# **City of Plymouth Plan Commission**

The City of Plymouth Plan Commission will have a meeting on **Thursday, April 3, 2025 at** 6:00 PM in **Room 305**, City Hall, and Plymouth, WI.

- 1.) Approval of Minutes from March 6, 2025.
- **2.) Site Plan Seeking Approval;** 3062 Kiley Way, Kensington Management, Inc. (dba Taco Bell) for exterior site plan improvements. Excel Engineering (enclosure)

### CERTIFIED SURVEY MAP

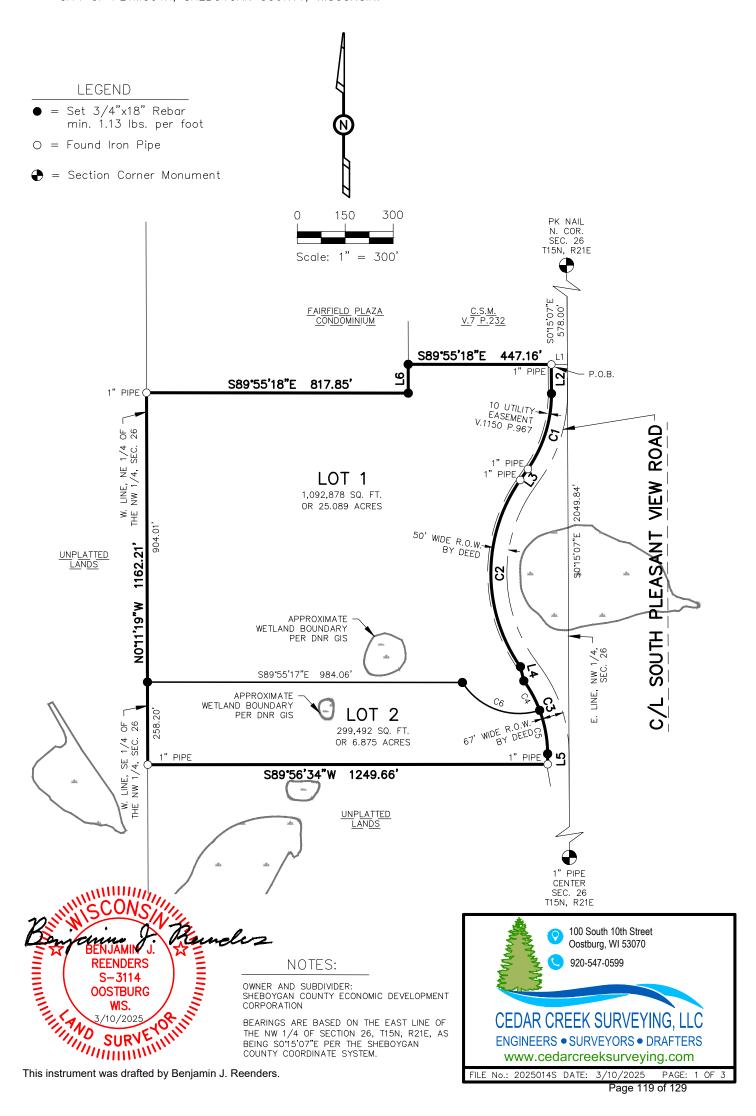
Ch./Sec.	<u>Comment</u>
236.34 (1m)(c)	The map shall be prepared in accordance with ss. 236.20 (2)(f) The exact width of all easements, streets and alleys.  Add the foot symbol to the 10' utility easement shown on Sheet 1.
	The map shall be prepared in accordance with ss. 236.20 (2)(k) All curved lines shall showthe central angle subtended.  The deltas for Curve C4 and C5 don't add up to the delta shown for Curve C6. Change the delta for Curve C4 to 15°21' <u>09</u> " on Sheet 2.

236.34 (1m)(d)(1.)	By whose direction the professional land surveyor made the survey, division, and map of the land described on the certified survey map.  Include the "by whose direction" information with the beginning portion of the Surveyor's Certificate on Sheet 2.
14-1-42 (c) (2)	Setbacks or building lines required by the common council and the city Zoning Code. On Sheet 1, list the setbacks according to the appropriate zoning for Lot 1 and Lot 2.
14-1-42 (c) (6)	Name and address of the owner, subdivider and surveyor. Add the address to the owner/subdivider name at the bottom of Sheet 1.
14-1-42 (c) (8)	Present zoning for the parcels. On Sheet 1, label the appropriate zoning for Lot 1 and Lot 2.
14-1-42 (e)	Certificates. The common council, after a recommendation by the reviewing agencies, shall certify its approval on the face of the map. Add a common council approval certificate to Sheet 3.
